## Finding of No Significant Hazard

## 3.9.2 Fuel Handling

## Description of tests in proposed changes to TS 3.9.2.1

**Figure 2.** Fuel element latched in position H-7 (note: in this prototype the fully latched green triangle is about  $2^\circ$  off of the actual fully latched position. This will be corrected in future prototype and design development.)

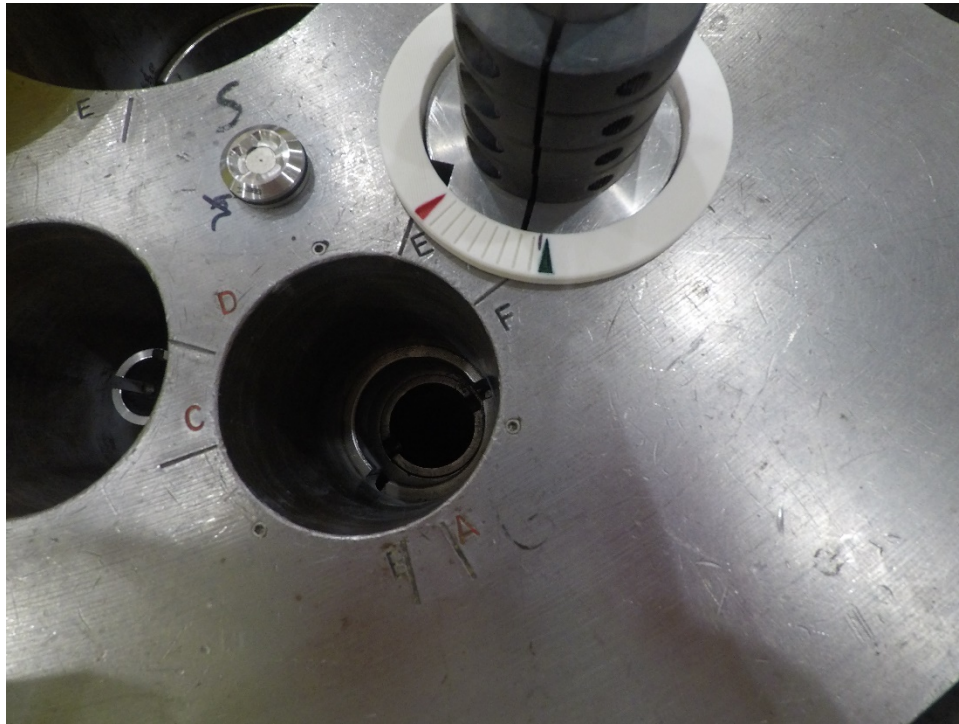
Prior to removal of the tool from the head, the azimuthal position of the collar affixed to the tool is checked against fiducial marks on a sleeve inserted into the element position in the index plate. Figure 2 shows the rotational check on a fully latched element against a prototype sleeve that is slipped into the tooling plate and that has fiducial marks indicating latched (green triangle) and fully unlatched (red triangle). These marks are true fiducial marks in that they relate back to machined notches in the bottom of the tooling plate that are true to the cartesian axis system of the upper grid plate. Figure 3 shows the rotational check of the same element with the latch bar in a position that is still within the notch, but rotated in a clockwise direction. Note that, although latched, this element *would be assessed as unacceptable* and would need to be rotated so that the indication aligns with the green fiducial reference mark. Obviously, elements found rotated further clockwise (and likely out of the notch) would also be found unacceptable. Variations of rotation angles due to tolerances in the upper grid plate and notches are being evaluated and will be clearly indicated on future designs of the marked sleeve to give a clear “passing” criterion.

**Figure 4.** Video capture of element in latched position (core position I-6)

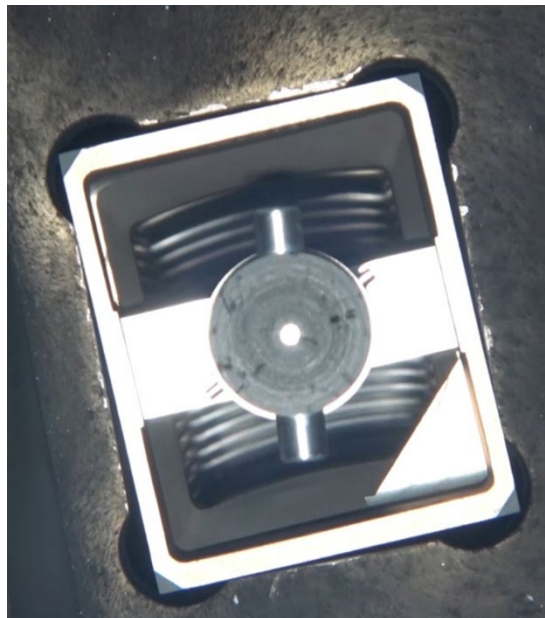
Photos of the video results of a test with a fully latched element in core position I-6 is shown in Figure 4. A photo of the H-7 element rotated about 6° off of full counterclockwise (the same as in Figure 3) is shown in Figure 5. The difference between the two can be easily seen, as the “ears” of the rotated element are clearly off perpendicular and would be rejected. Further rotation clockwise would also have the latch bar coming into view. As in the rotation check, evaluations are being made to clearly define acceptable visual check angle deviations.
